## Heintz and Kaufman, Ltd. ANNOUNCE! THE 354-C GAMMATRON

Improved ULTRA-HIGH Frequency Operation. Same electrical characteristics as the "354" GAMMA-TRON—PLUS:

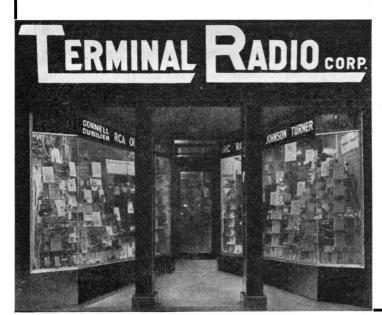
- Increased filament to grid insulation.
- Input capacity reduced to onehalf.
- Extremely short grid lead.
- New grid and plate cap that can't come loose.
